To	John McKee	Contact No.	02 9239 7330
Copy to	Murray Walsh	Email	Marco.velasco@ghd.com
From	Marco Velasco	Project No.	12582654
Project Name	DA2024.109 – Blasting Impact Assessment		
Subject	Additional information requested by Transport for NSW

Table 1 *Transport for NSW additional information and assessment*

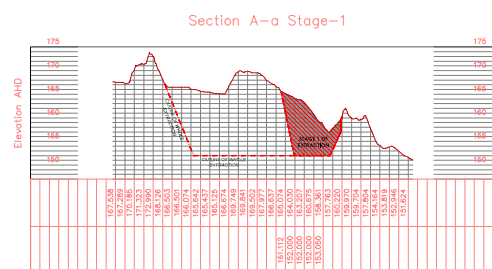
Additional information required	Where addressed
Blasting location: The Environmental Impact Statement (EIS) and supporting information submitted with the DA do not clearly show where the blasting is proposed within the quarry, particularly in relation to the Princes Highway now and over the course of the quarry operations for which blasting will be used, which the EIS indicates will last a minimum of 30 years. To begin assessing the impacts the blasting will have on the Princes Highway, TfNSW requires a plan showing where the blasting is proposed over the quarry's life and to what depth.	A blast extraction plan has been produced by BSE Consulting and is provided in Appendix A and discussed in Section 2.
Flyrock: The calculated maximum flyrock distances in the Blasting Impact Assessment report are a concern for TfNSW given the quarry's proximity to the Princes Highway road reserve (e.g. approximately 107m from the existing quarry face and approximately 53m based on the external excavation area displayed on the Site Layout Plan). The maximum throw distance of 94m, as calculated in the 'Blasting Impact Assessment' report (Appendix E, prepared by GHD, Project No: 12582654, Revision 1 dated 22.5.24), indicates that the Princes Highway could be directly impacted. Although the report references "flyrock control management measures" (Section 4.3), it lacks specifics. TfNSW requires the applicant to outline the intended flyrock management measures for the Princes Highway.	Additional assessment of flyrock impacts has been provided in Section 3.

Vibration: TfNSW records indicate two reinforced concrete culverts located on the Princes Highway, adjacent to the quarry (Culvert No. 612242 and 612243 – refer to Attachment 2). The Blast Impact Assessment report, details that the maximum peak particle velocity of 80mm/s for reinforced concrete pipes as referenced from German Standard DN41. Andrew agreed 50-3 Table 2, is considered acceptable for these structures. TfNSW requires the applicant to outline how vibration monitoring at these structures will be carried out to ensure that this level is not exceeded, notify TfNSW when/if 80mm/s is exceeded	Additional assessment of vibration impacts to the two culverts has been provided in Section 4.

Additional information required	Where addressed
on any blast and detail when dilapidation surveys of the two culverts will be undertaken by the proponent (e.g. once a year) and that approval/advice from TfNSW on the dilapidation survey will be obtained and any works required to repair damage caused completed before blasting recommences.

Blasting is proposed in three stages to a design depth of 150m AHD consistent with the existing pit floor level. Each stage would occur for a period of 10 years, starting from the southeast of the extraction area and progressively moving towards the northwest of the extraction area.

The blast extraction plan prepared by BSE Consulting is shown in Appendix A and shows the overall extraction area and the horizontal and vertical extents of the Stage 1, Stage 2 and Stage 3 extraction area.

The approximate nearest distances from each extraction area to the Princes Highway road reserve, Culvert No. 612242 and Culvert No. 612243 is shown in Table 2.
